BCAC IRC 3-2/IBC 10-4 Emergency Escape and Rescue Openings

Revised 9-12-2018

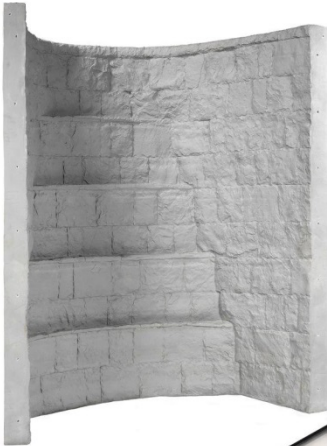
The current provisions says ladders and steps don't have to comply with the standard stairway provisions, however, while specific provisions are provided for ladders, no limits are provided for steps. The option here it the same width and distance between steps are permitted for ladders. The tread depth is the minimum width from alternating tread devices and ships ladders.

Following are examples of stepped configurations that are used today. The proposed language would allow for the use of Figures 1 and 3, but not 2 and 4.

R310.4.2.2 Steps. Steps shall have an inside width of at least 12 inches (305 mm), shall have minimum treads depth of 5 inches (127 mm) and a maximum riser height of 18 inches (457 mm) for the full height of the area well.
